#### RE: **"Other Business" Application No. 57 (2023) Agreeable Stipulations, Revised Site Plan and Additional Information** Applicant: Susan H. Pryor Subject Property: 275 Lane Dr. Mableton, GA 30126

## SPR-2023-00317

Lot Division and Retracement Survey for:

#### ITEM OB-57-2023

# 1-2

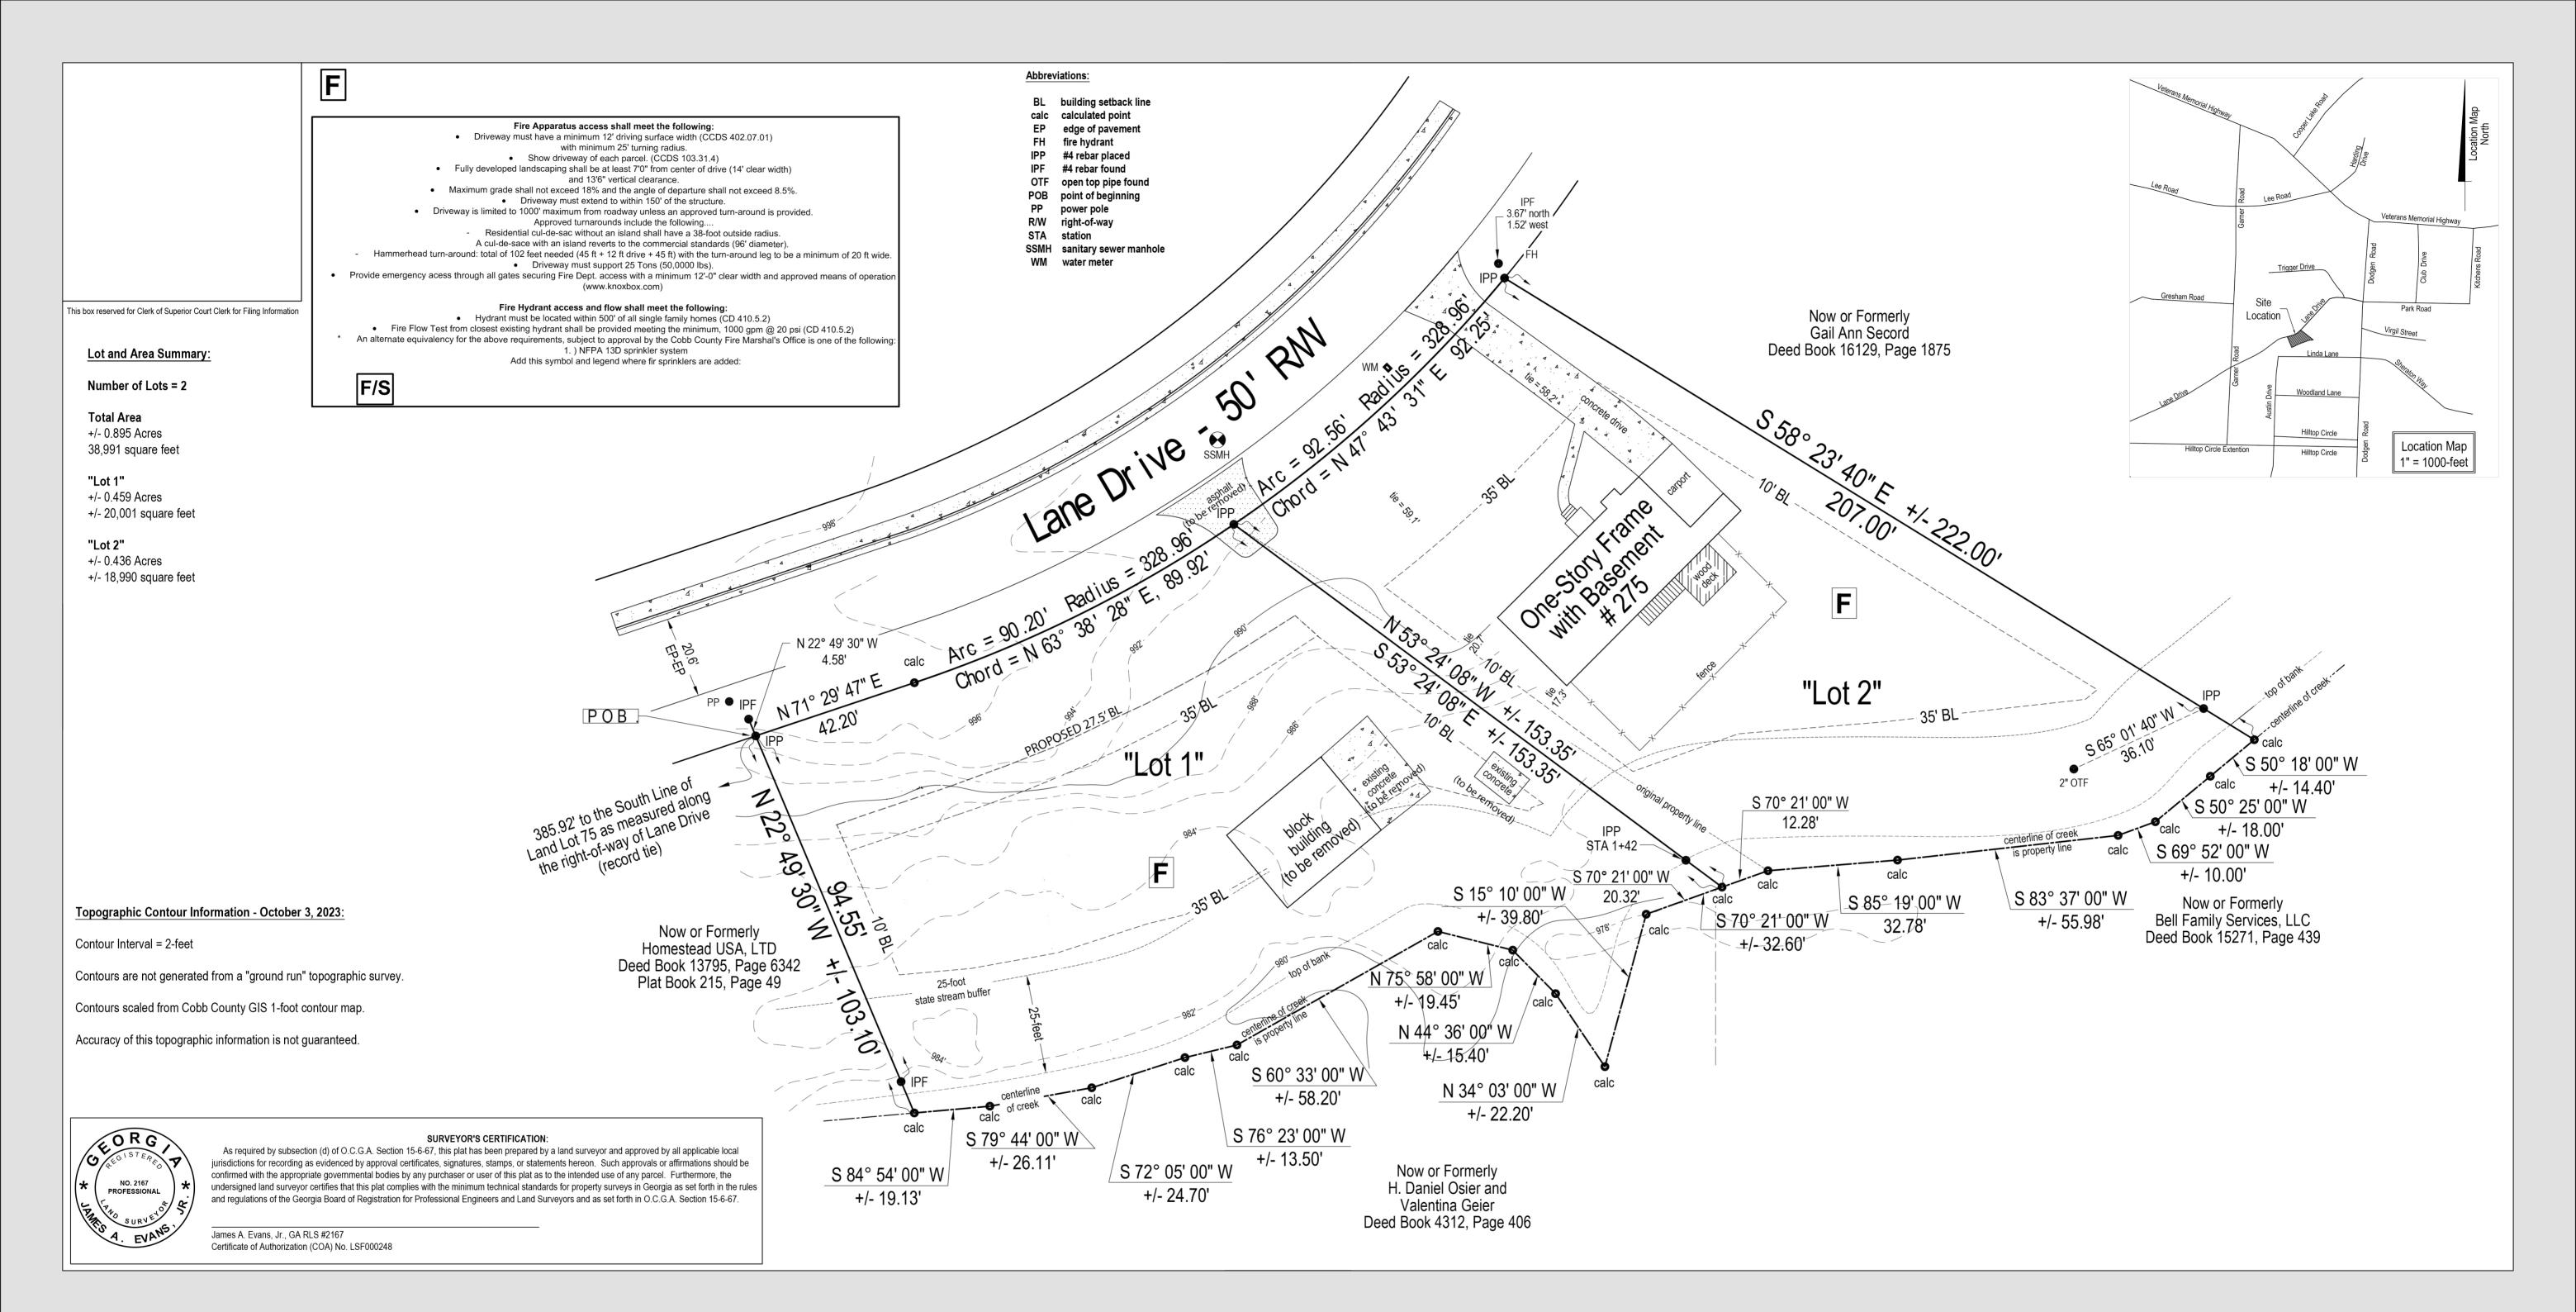
An updated Lot Division Plan dated October 3, 2023 is attached hereto and replaces the version submitted with the application. This version of the Lot Division Plan was developed as a result of conversations with County departmental staff and members of the Applicant's project team. Changes included in the revised Lot Division Plan are:

- 1. The proposed 27.5' front setback / building line is shown on Lot 1 as per the request in the Application,
- 2. The 50' and 75' stream buffers have been removed,
- 3. Additional existing structures on Lot 1 are labeled 'to be removed'

- B. Compliance with the comments and recommendations of the Cobb County Department of Transportation (DOT) inclusive of the following:
  - 1. Donation of land area for the purpose of right-of-way (ROW) on the south side of Lane Drive. The new ROW shall extend 25' from the center line of the existing roadway as currently shown on the revised Lot Division Plan dated October 3, 2023 and attached hereto.

2-2 JAE Job# 230080

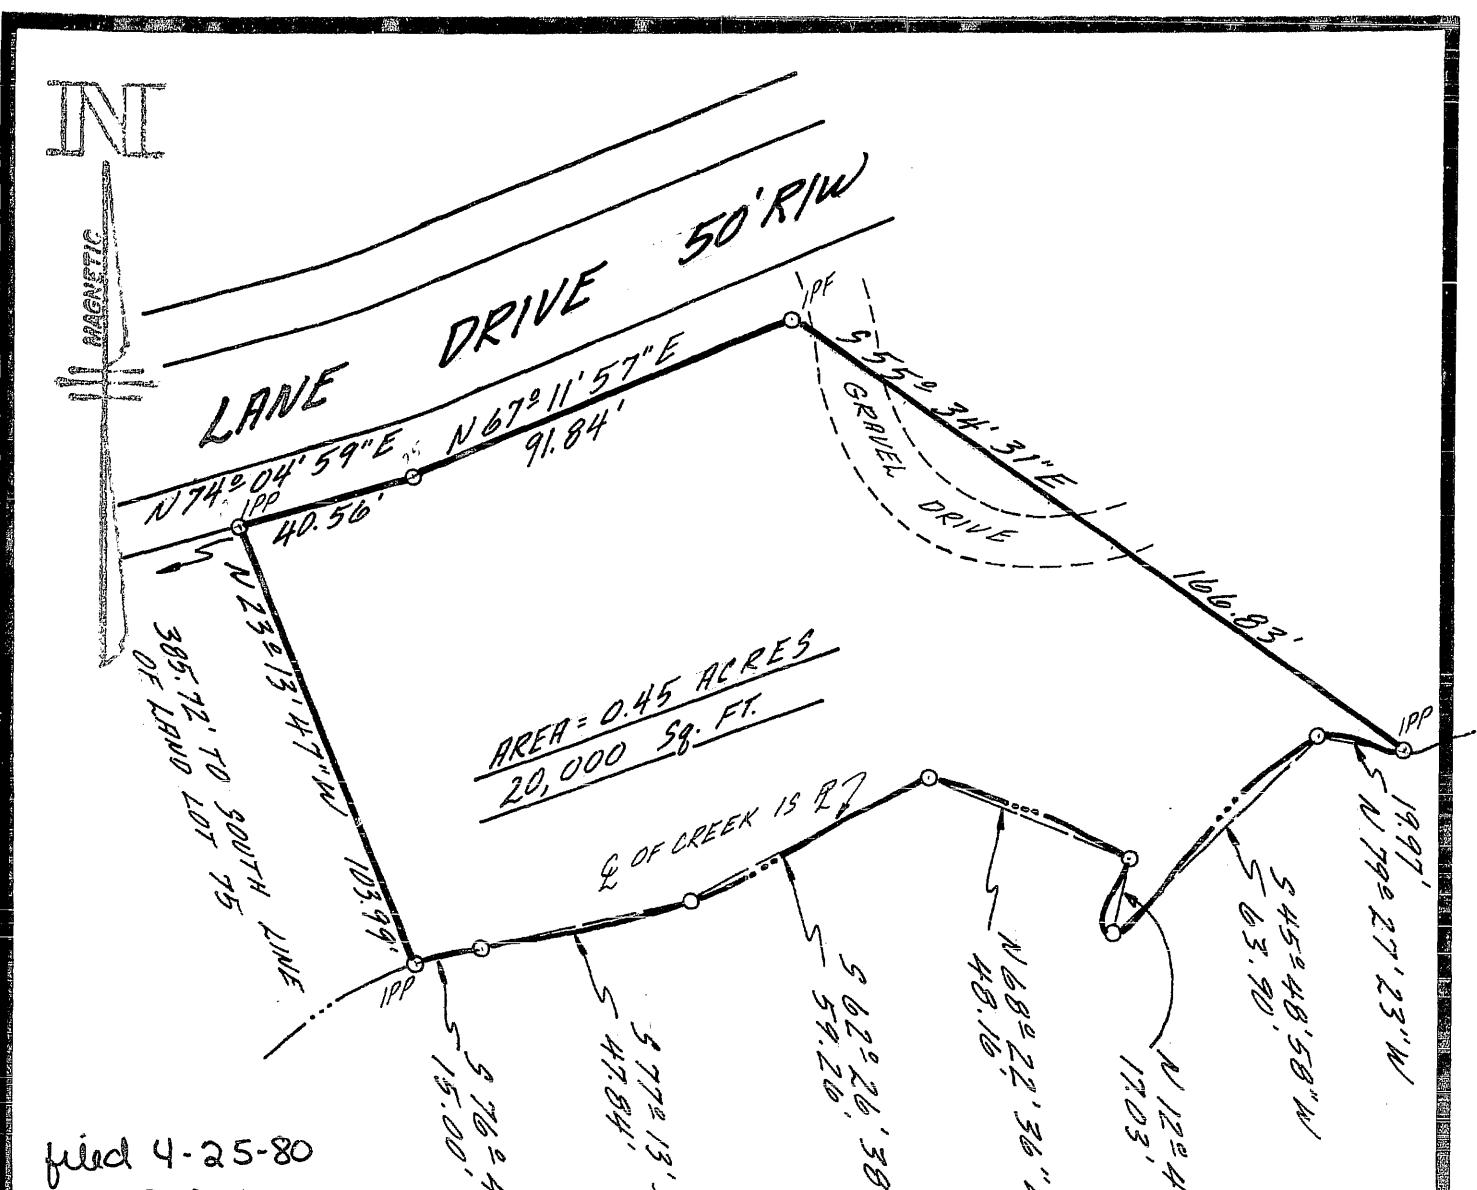
Lane Drive is classified as a Local roadway and according to the available information the existing right-of-way does not meet the minimum requirements for this classification.

- Recommend applicant confirm that Lane Drive has a 50' public right of way or consider entering into a development agreement pursuant to O.C.G.A. 36-71-13 for dedication of the following system improvements to mitigate traffic concerns: a) donation of right-ofway on the south side of Lane Drive, a minimum of 25' from the roadway centerline. This recommendation is pursuant to Cobb County Development Standard 401.2, Right-of- Way.

- 2. Recommend applicant verify that minimum intersection sight distance is available for Lane Drive access. This recommendation is pursuant to Cobb County Development Standard Detail 401B, Intersection Sight Distance. If minimum intersection sight distance is not available, recommend implement remedial measures to address safety, subject to the Department's approval, to achieve the minimum requirement of 280'.

- 5. Recommend driveways on Lane Drive be paved with a treated hardened surface for a minimum of 25' from the edge of pavement or to the County right-of-way, whichever is greater in length. This recommendation is pursuant to Cobb County Development Standard 402.7.1, Residential Driveways and Cobb County Development Standard Detail 116R, Residential Driveway Standard.

With respect to the information provided herein, this letter constitutes the Applicant's agreement with the stipulations as identified below. This agreement is subject to the Application approval in substantial conformity to the revised Lot Division Plan submitted concurrently with this document. The Applicant agrees that the following stipulations shall become binding conditions upon the approved application (language is specific to ITEM OB-57-2023 case notes made available to applicant's representative on November 9, 2023 and attached hereto):

- 2. Compliance with sight distance requirements for the driveway / access to Lane Drive.
  - 3. Compliance with residential driveway design requirements pursuant to Cobb County Development Standard 402.7.1 and Standard Detail 116R Residential Driveway.

- Driveways on Lane Drive will be treated with a hardened surface pursuant to Cobb County Development Standard 402.7.1 and Standard Detail 116R – Residential Driveway.
